NUCLEAR STATION PROCEDURE ROUTING

REMOVE: DSSP 0010-01 Rev. 03

INSERT: DSSP 0010-01 Rev. 04

DETERMINING SAFE SHUTDOWN PATHS FOR EXTENSIVE PLANT DAMAGE

Figure 1

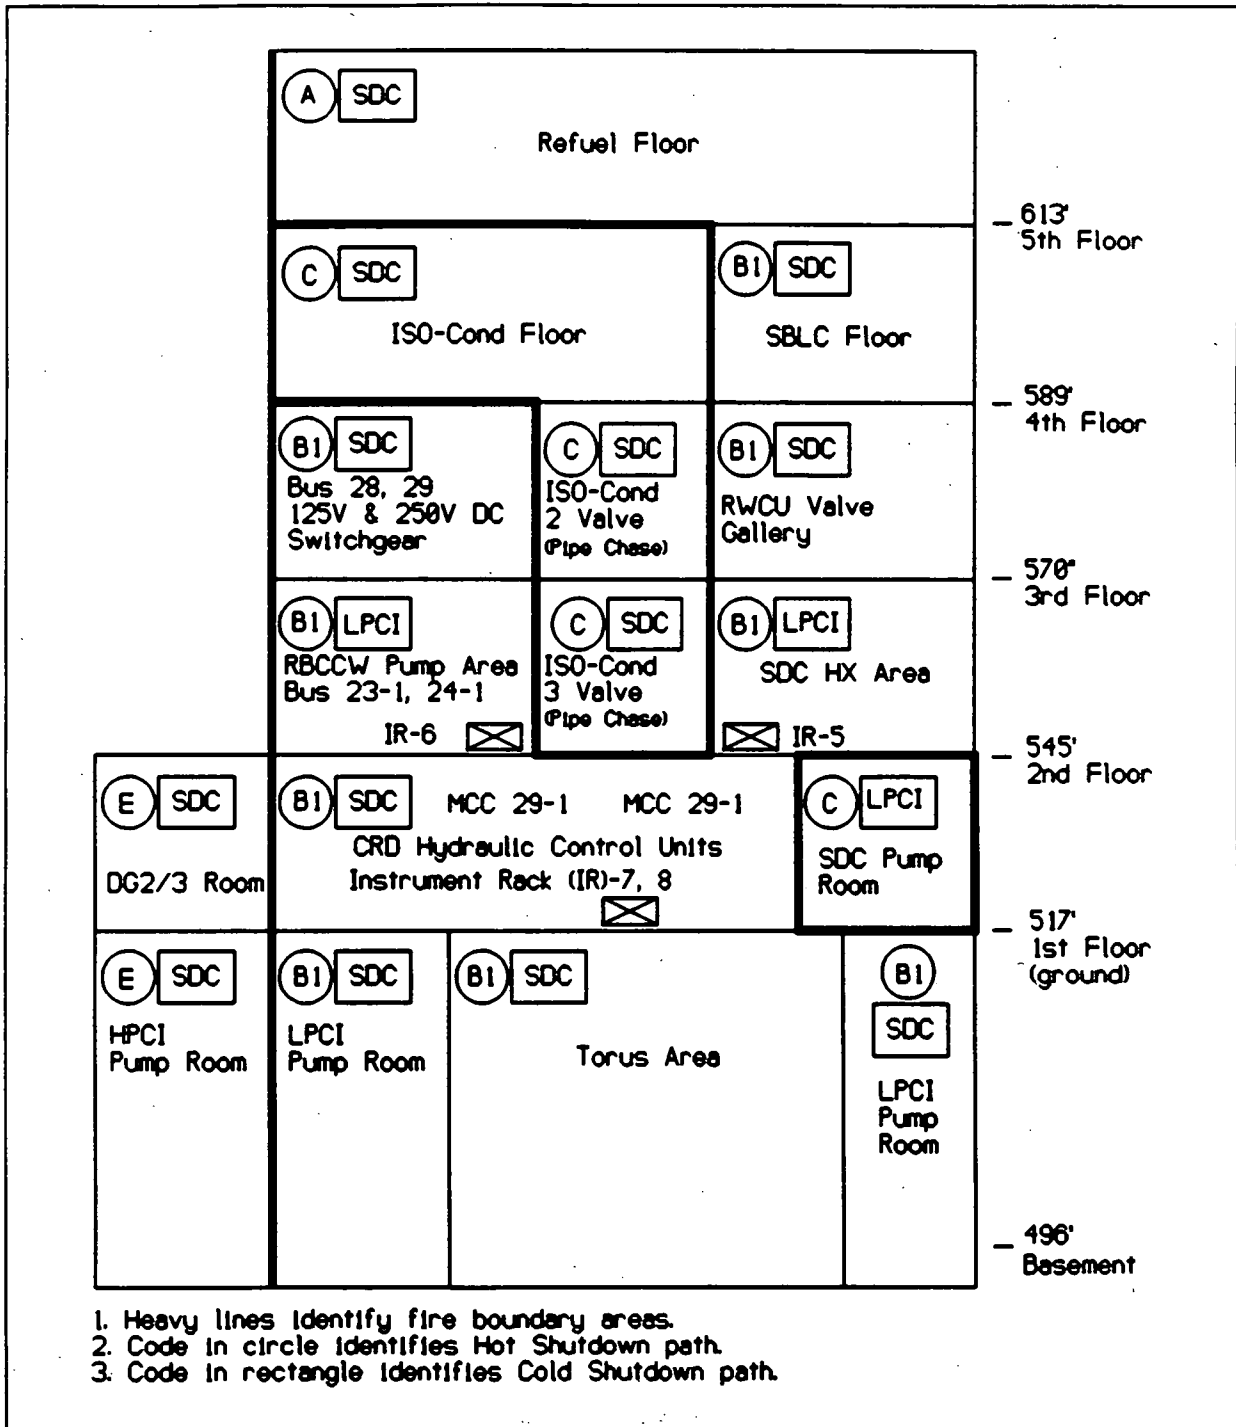
Description and JUSTIFICATION for procedure or change: Correct typos in Figure 1 and Figure (Fig 1, change MCC 29-1 to 28-1; Fig 2, Change MCC 29-1 to MCC 38-1 and 39-1). Added MCC 29-4 as this is in fire area. Changed EPIP 200-T1 to 0200-01. EIPs were recently revised. This change reflects the new procedure numbers.
